# HISTORIC AND DESIGN REVIEW COMMISSION

**HDRC CASE NO:** 2020-493  
**ADDRESS:** 815, 875 E ASHBY PLACE  
**LEGAL DESCRIPTION:** NCB 3053 BLK LOT E 169.12 FT OF 13, W IRR 42.38 FT 14, P-100 (0.142 AC) & P-101 (0.3304 AC)  
**ZONING:** IDZ-3, RIO-2  
**CITY COUNCIL DIST.:** 1  
**APPLICANT:** Ashley Farrimond/Killen, Griffin & Farrimond, PLLC  
**OWNER:** Borden River Road LP  
**TYPE OF WORK:** Construction of a pedestrian river bridge  
**APPLICATION RECEIVED:** October 30, 2020  
**60-DAY REVIEW:** Not applicable due to City Council Emergency Orders  
**CASE MANAGER:** Edward Hall

The applicant is requesting a Certificate of Appropriateness for approval to construct a pedestrian bridge across the San Antonio River to the immediate south of the Highway 281 bridge.

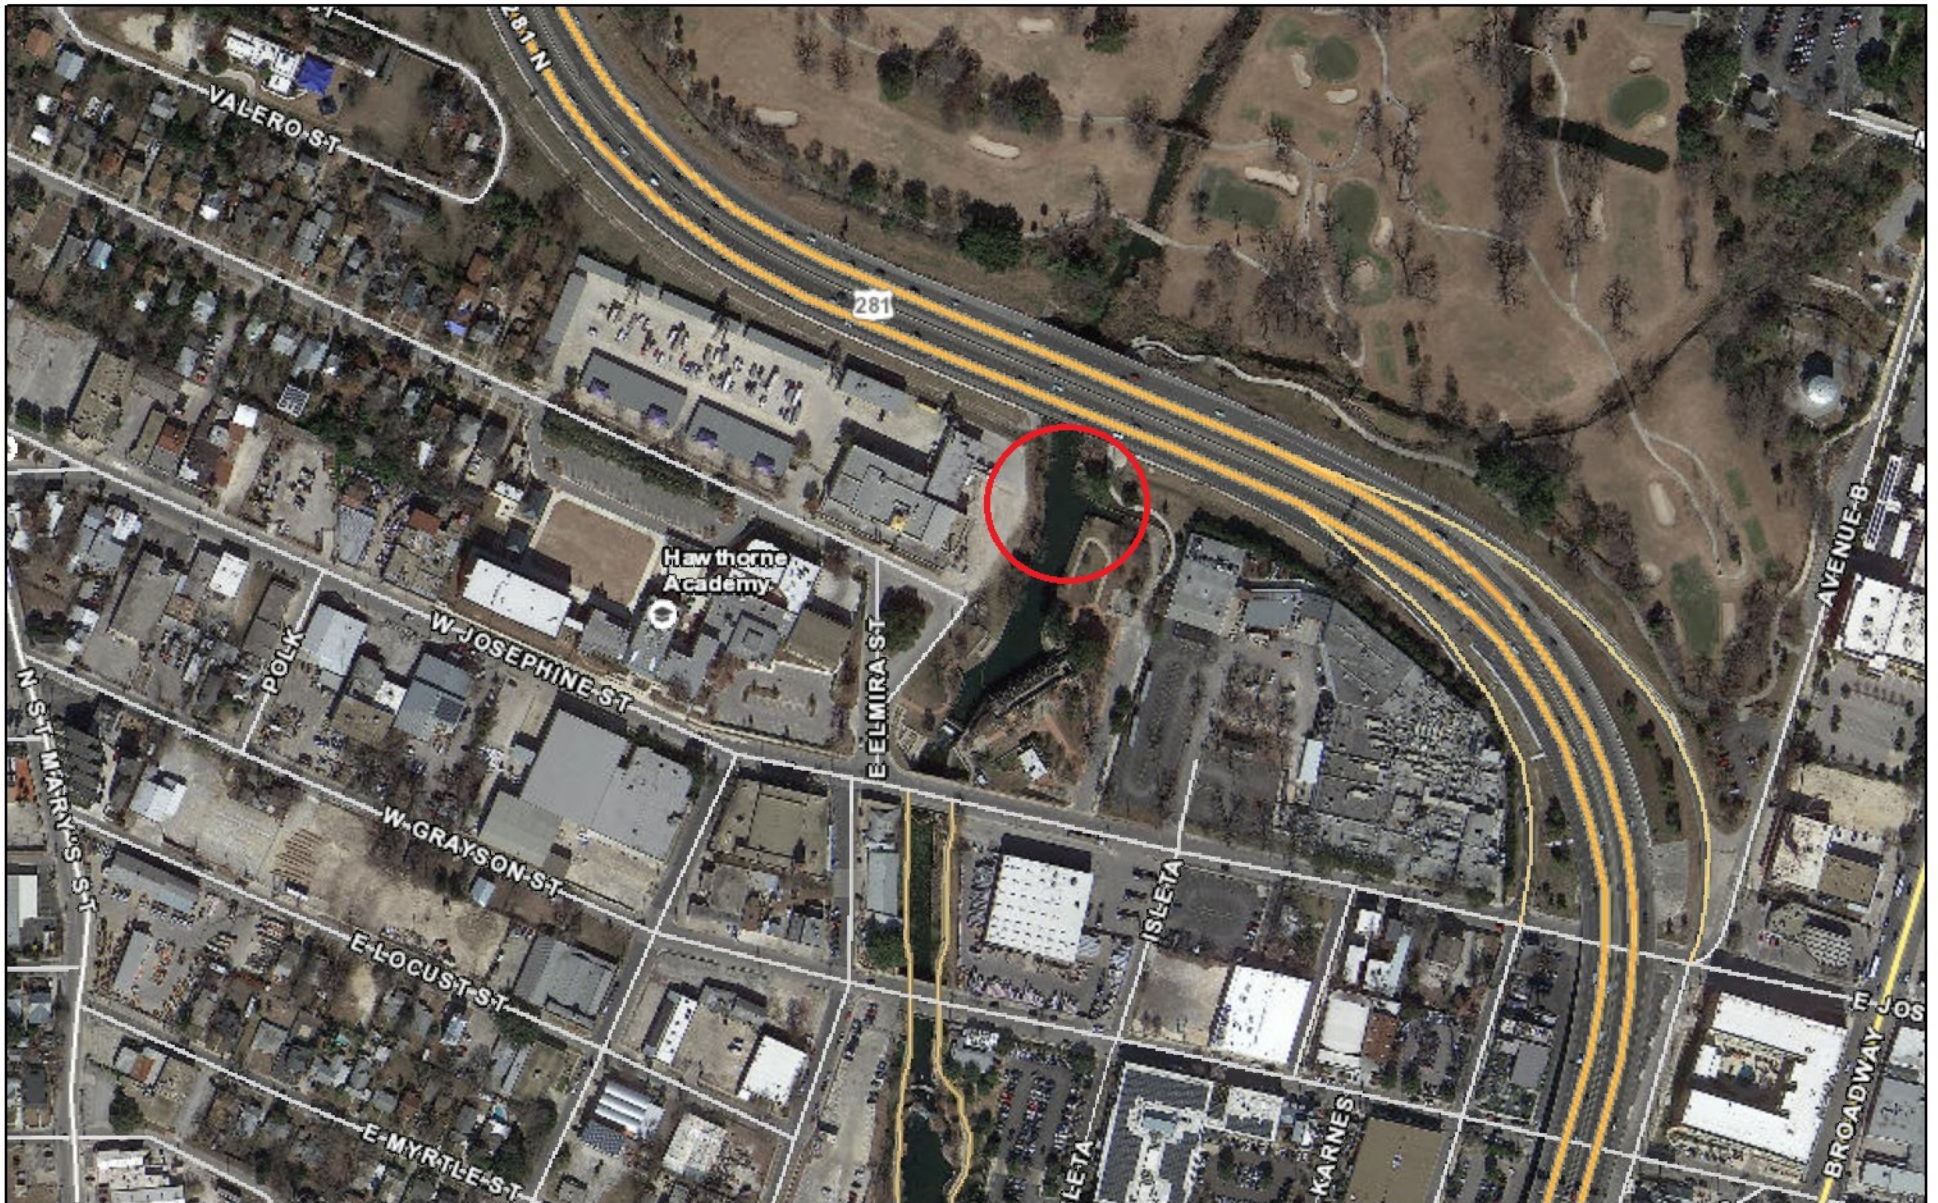
hat the final design of the proposed river bridge return to the Commission for approval. Additionally, the applicant is to coordinate with the San Antonio River Authority, COSA Transportation & Capital Improvements, COSA Parks & Recreation, and any other regulatory body, as required.

- c. PEDESTRIAN BRIDGE – The applicant has proposed for the pedestrian bridge to feature steel construction with a concrete deck, and steel railings of approximately five (5) feet in height. The bride will also feature the installation of a concrete retaining wall within the river channel. Staff finds the proposed design to be appropriate.
- d. ARCHAEOLOGY – The project shall comply with all federal, state, and local laws, rules, and regulations regarding archaeology, as applicable.

**RECOMMENDATION:**

Staff recommends approval based on findings a through c with the following stipulation:
